MEMORANDUM

REVIEW TYPE: Preliminary Plan of Subdivision, Resubdivision of Existing Lot 121, Belvedere

PROJECT NAME: Belvedere

CASE #: 120060790

PRELIMINARY PLAN
Belvedere - Lot 121 Resubdivision
 13604 Stonebarn Lane
 POTOMAC, MARYLAND
 ANNE ARUNDEL COUNTY, MARYLAND

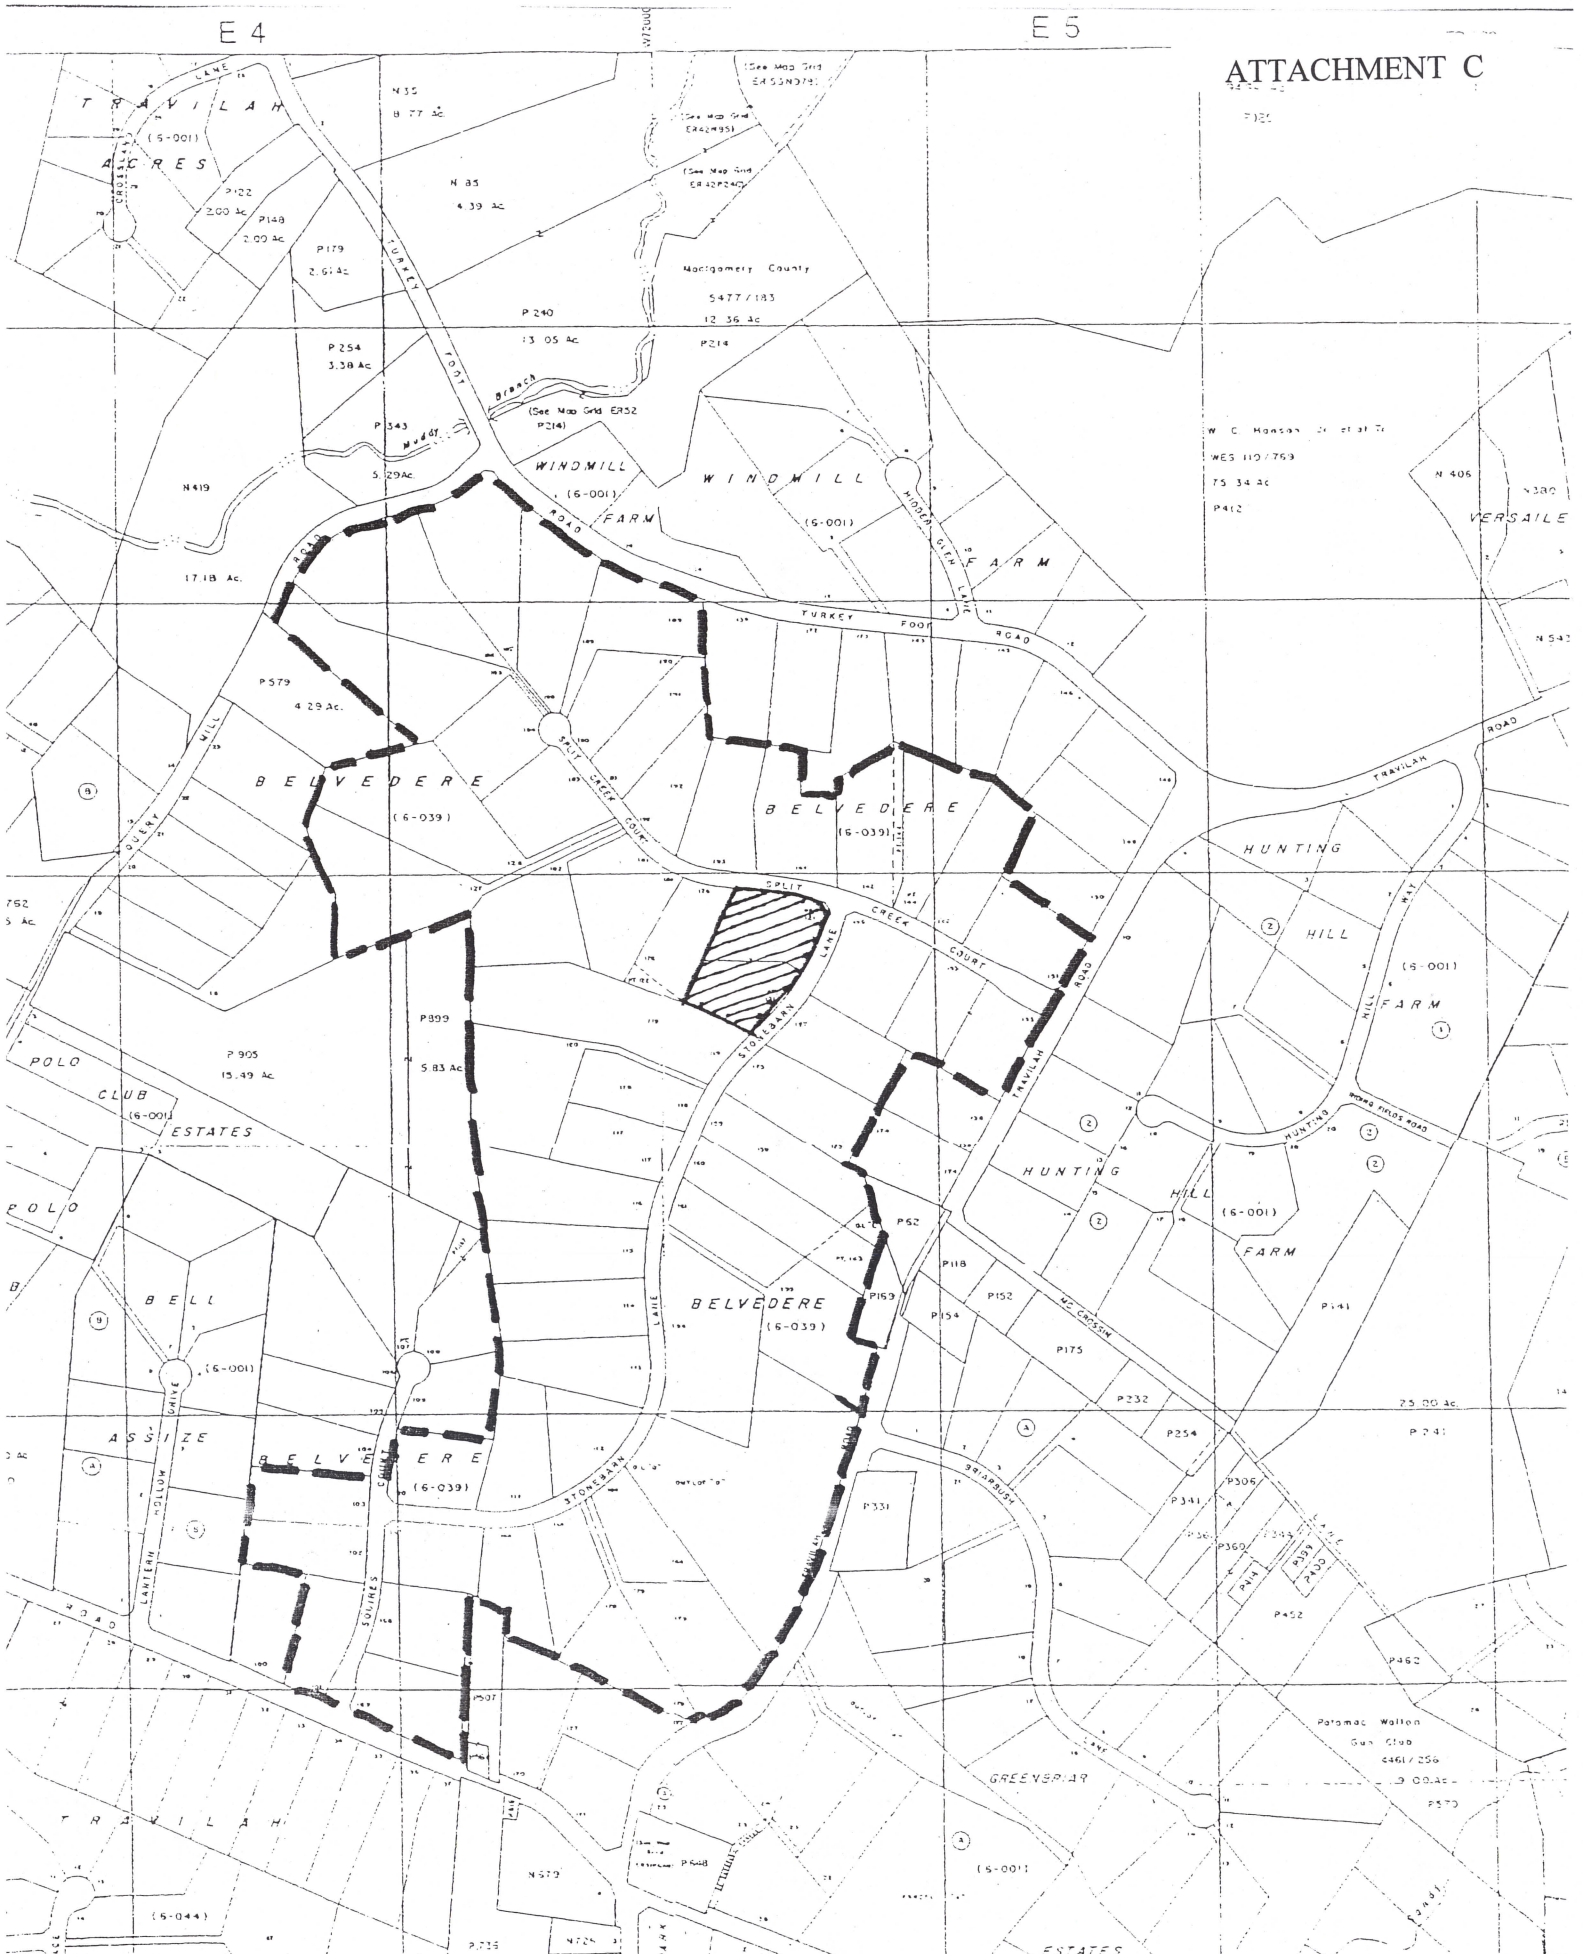
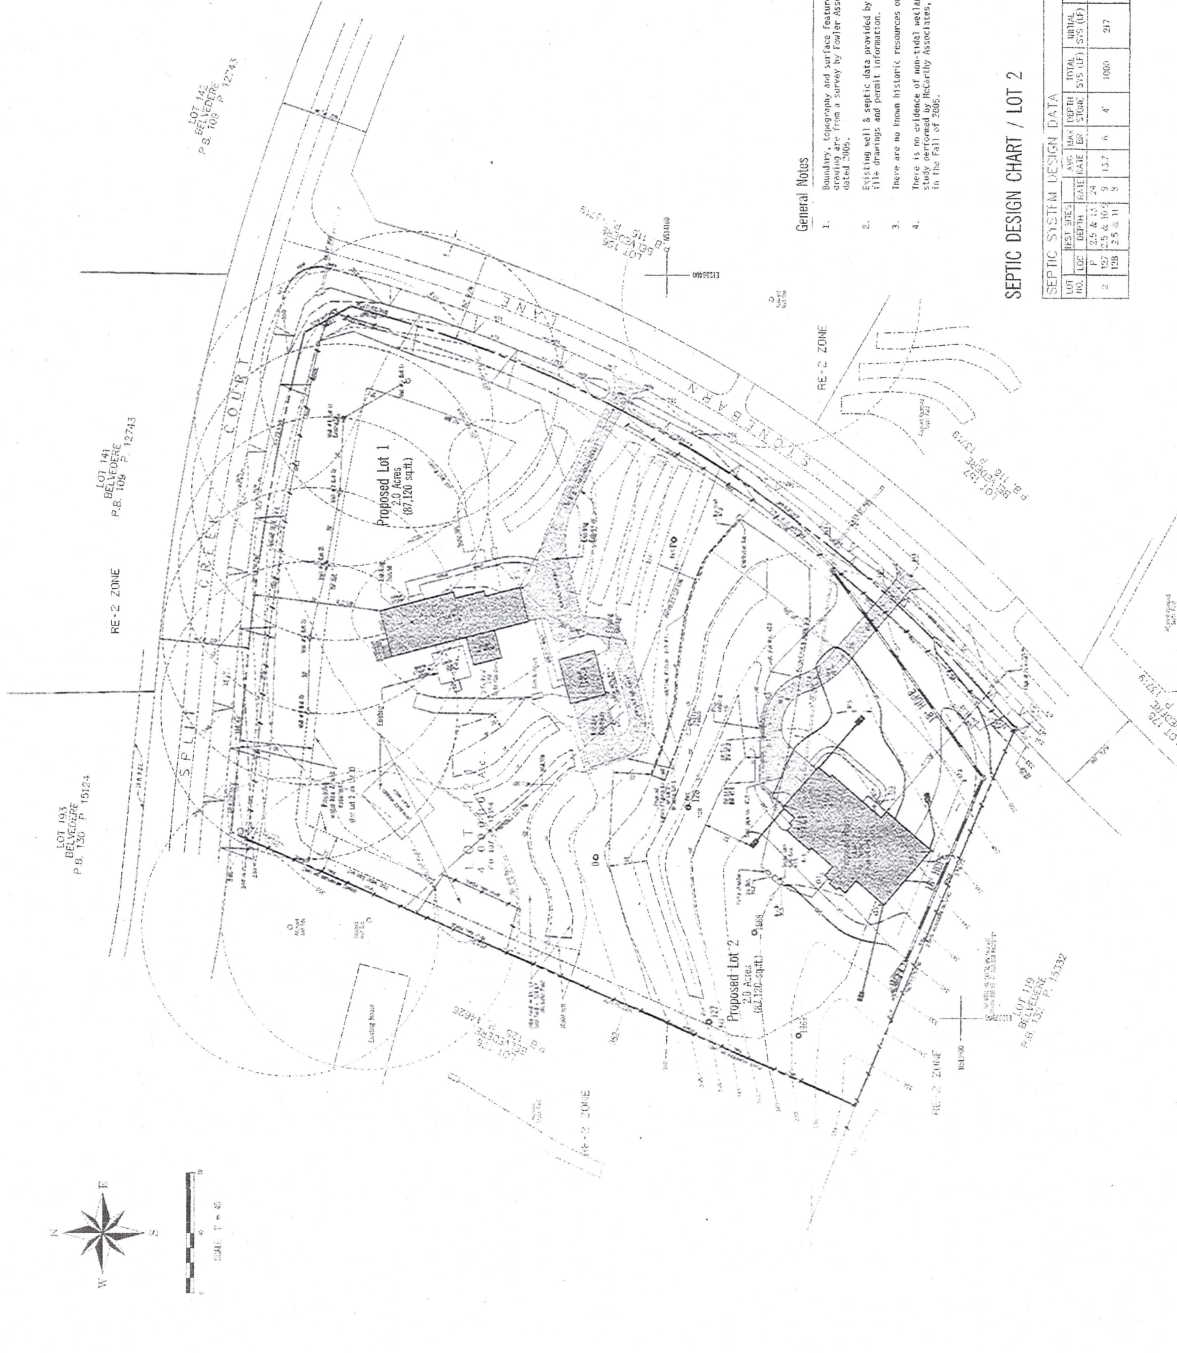
1. The record plat must be at the same scale as the preliminary plan, or submit an enlargement of the plat to match the preliminary plan.
2. The septic field that serves the existing garage on proposed lot 1 must be relocated prior to the approval of the record plat.
3. The well easement must be shown on the record plat as it is depicted on the preliminary plan.
4. All existing buildings must appear on the record plat.
5. The storm drain pipe that carries water under Stonebarn Lane must be relocated as shown on the preliminary plan.

1. Show all existing planimetric and topographic details (specifically driveways adjacent and opposite the site) on the preliminary plan.
2. Necessary dedication for Split Creek Court and Stonebarn Lane.
3. Grant necessary slope and drainage easements. Slope easements are to be determined by study or set at the building restriction line.
4. Wells and septic systems cannot be located within the right of way nor slope or drainage easements.
5. The sight distances study has been accepted. A copy of the accepted Sight Distances Evaluation certification form is enclosed for your information and reference.
6. Record plat to reflect a reciprocal ingress, egress, septic and public utilities easement to serve proposed lot 1.
7. Record plat to reflect denial of access along Split Creek Court.
